GMS Textiles Ltd.

13th January, 16th February and 3rd March 2020

Observations

Mezzanine

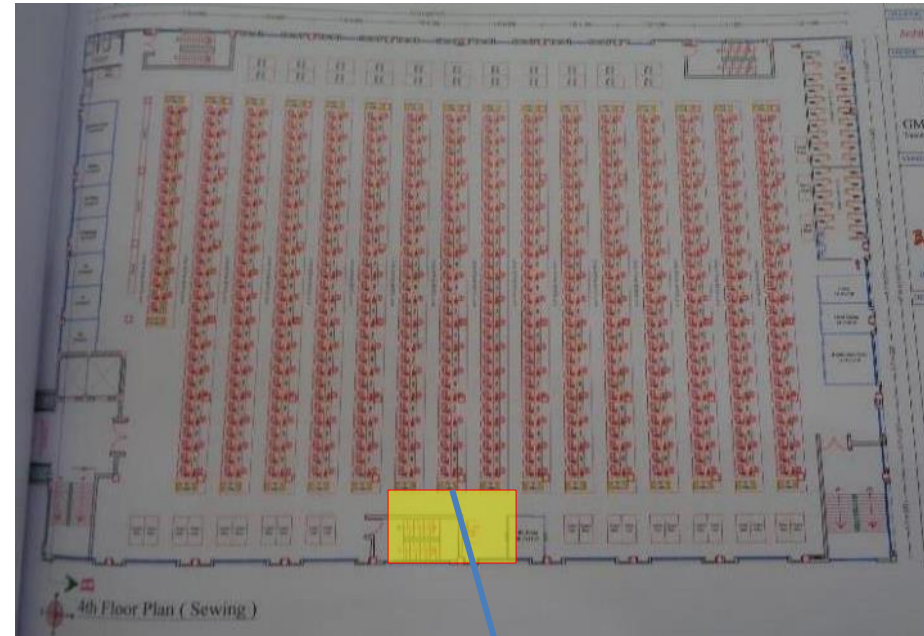
The location of marked stair is found mismatch in as-built structural/architectural drawings. The factory engineer is required to revise the location of the stair in the as-built drawings.

Mezzanine floor is being supported by some additional columns. No drawings details were found for the mezzanine floor.

Lack of as-built drawing of Connection bridges between B-2 and B-3

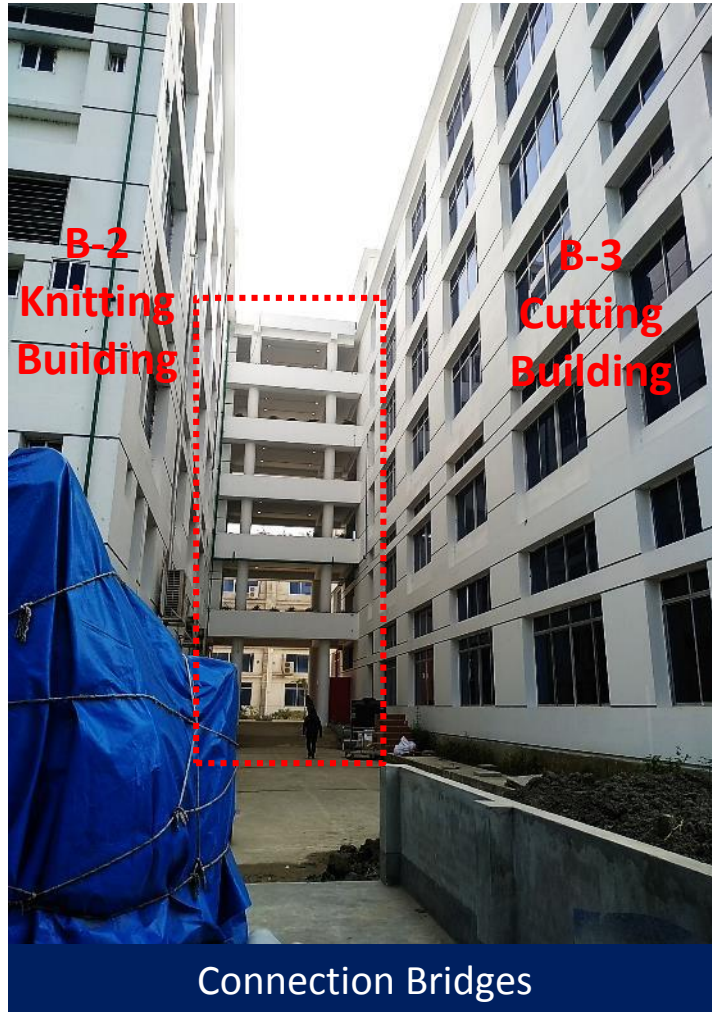
Connecting bridges were found between B-2 (Knitting Building) and B-3 (Cutting Building) at different floor levels. The connection bridges are structurally separated from both buildings. Factory engineer is required to prepare as-built drawings.

Observation : B-4 (Grey Fabric Store Building)

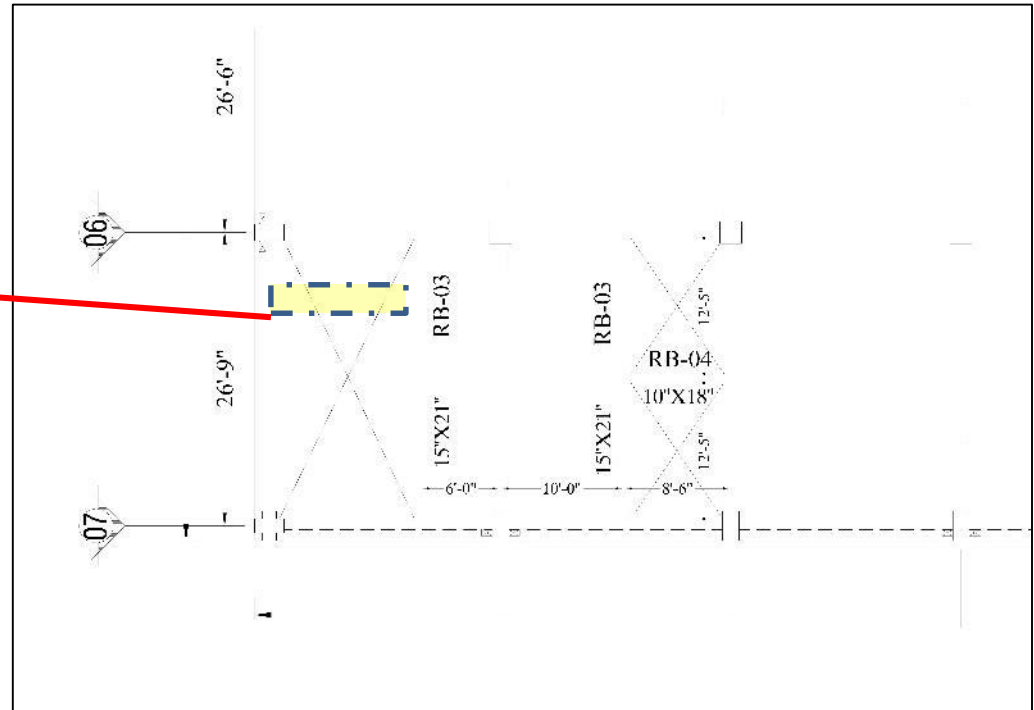
Some L-shape columns were found in Grey Fabric Store building. The size and number of rebar of these column were not matched with column schedule.

Extra beam on stair

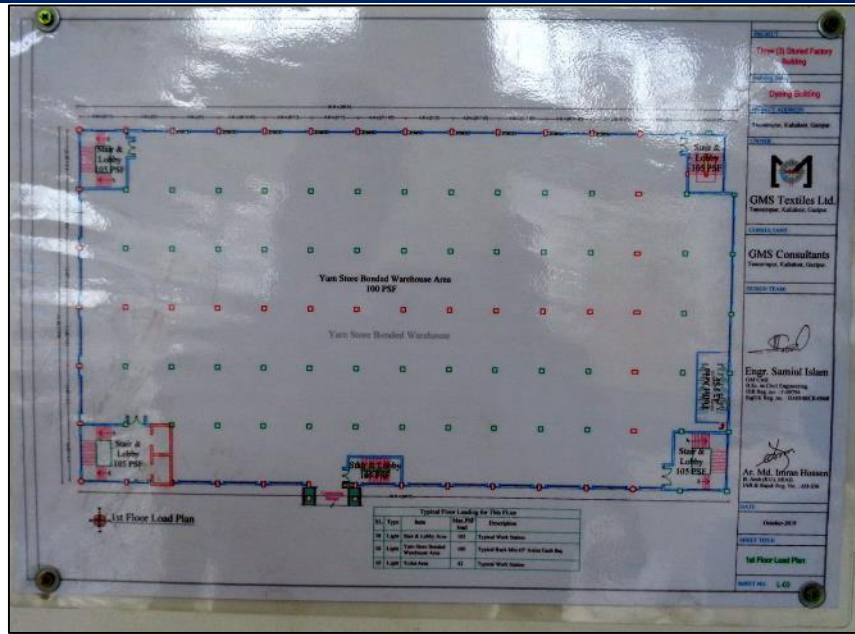
Extra beam was found on the south west portion between grid 07-08 and A-B. the measurement of the beam found to be 305 X 355 mm (d/s). This beam was found only on 1st floor.

Load plan posted on different floors

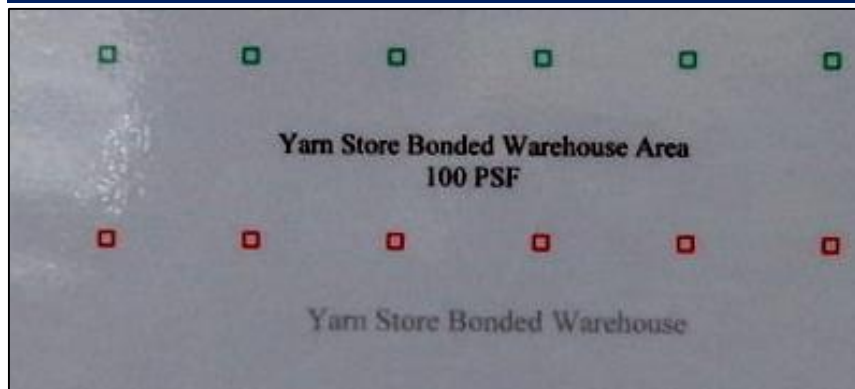
The load plan indicates the maximum allowable live load is 100 Psf (5 kPa). Though no calculation was provided to claim the rationality of using this load plan. No load height marking was observed.

Beam Offset from Column-Beam Connection

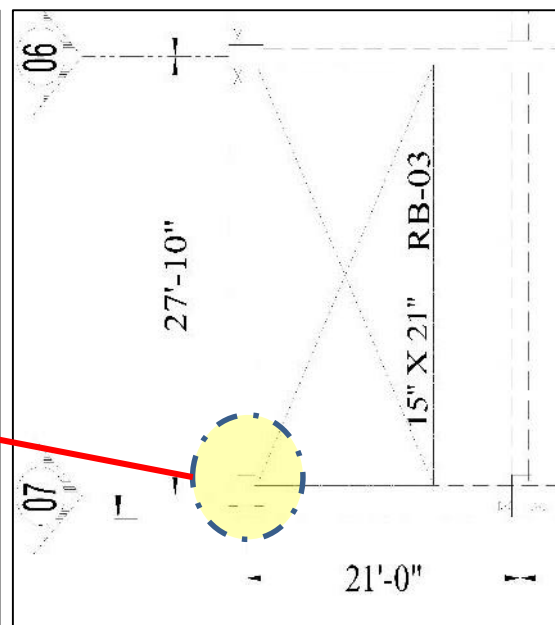
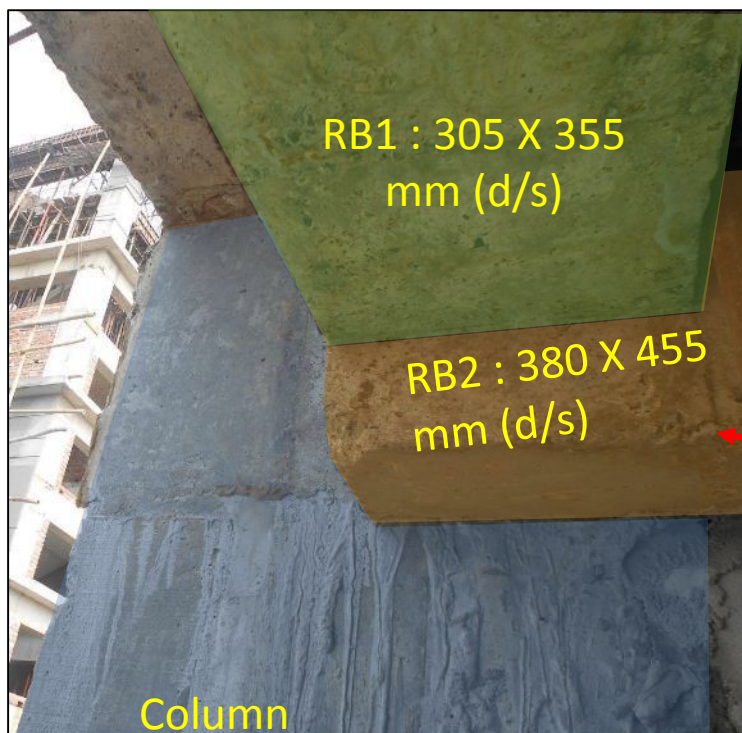
As per the drawing, RB02 was supposed to be connected to column with the edge. There was 125 mm offset found in RB02, which rise question of how the rebar of RB02 is joined with Column. The connection adequacy is required to be verified.

Observations: B-10 (Wastage Go-down Shed)

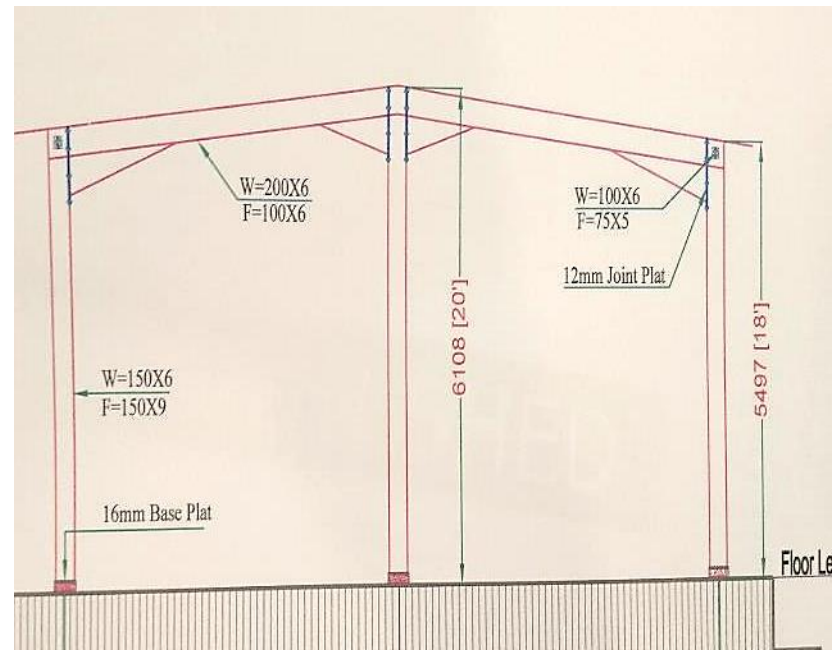
Flange thickness found 8.5 mm with coating for all internal columns

Flange thickness found 7.5 mm with coating for all periphery columns

Flange thickness was shown as 9mm for all columns

The factory engineer is required to produce accurate as-built structural drawings.

Lack of lateral stability

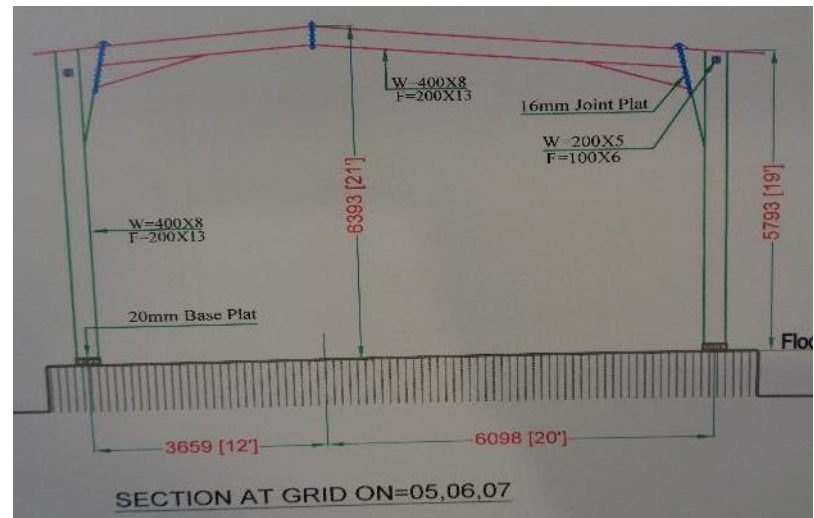
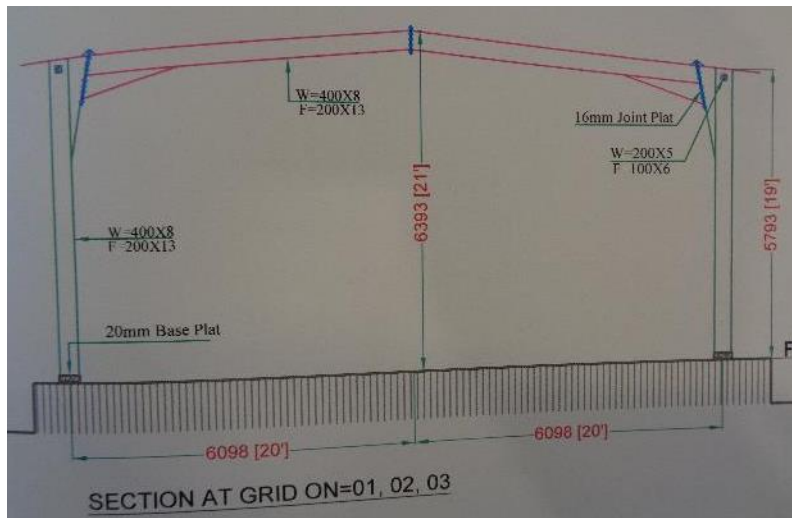
Compression strut provided along long direction without any bracing/tension member.

Horizontal and vertical bracing at roof and wall was not provided to complete the lateral stability system. The factory engineer is required to design and install the necessary bracings for lateral stability of the structure.

Section of two end grids

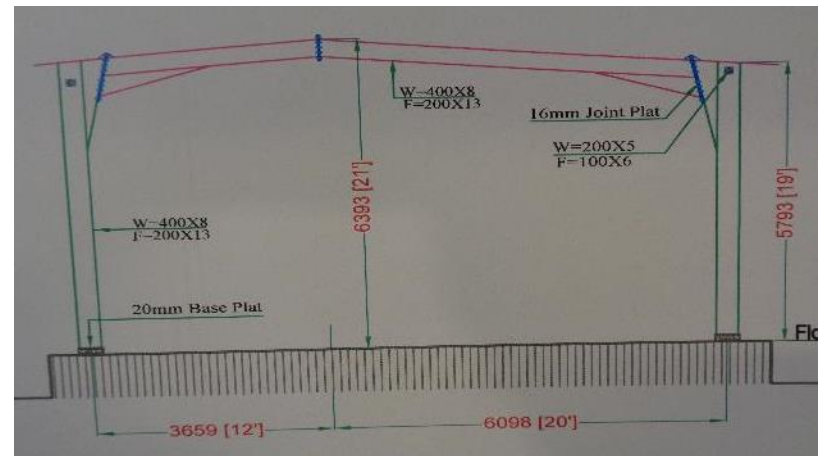
Marked steel columns at two end grids are not shown in provided drawing

Connection details of all connection are not shown in provided drawing
The factory is required to produce accurate as-built drawing with proper connection detail.

Insufficient lateral stability system

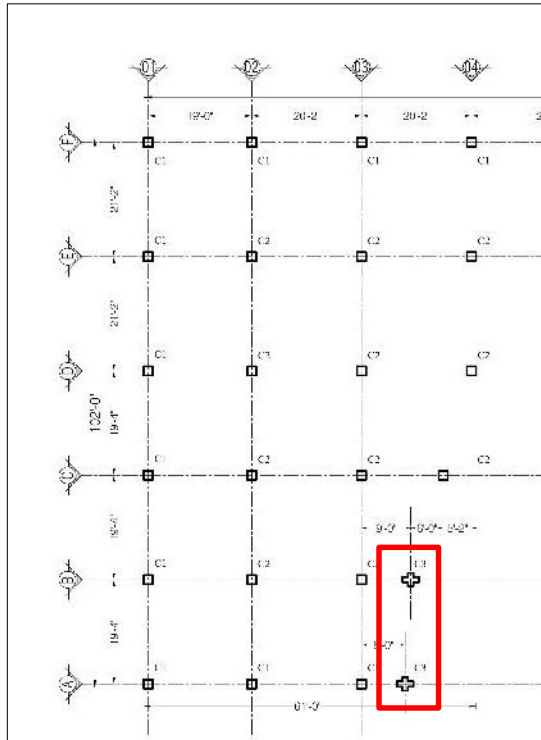
Compression strut provided along long direction without any bracing/tension member.

Horizontal and vertical bracing at roof and wall was not provided to complete the lateral stability system. The factory engineer is required to design and install the necessary bracings for lateral stability of the structure.

C3 Column

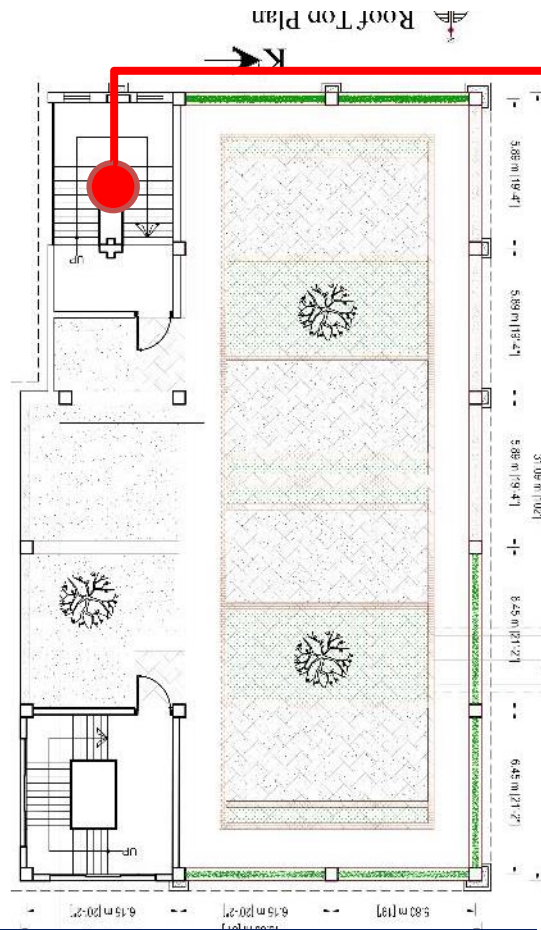
As per column schedule, the shape of C3 column on upper floors was to be rectangular shaped but on site it was found “+” shaped.

During inspection, a 3000 liters plastic water tank was found on the roof of southern staircase which not shown in as built architectural drawings.
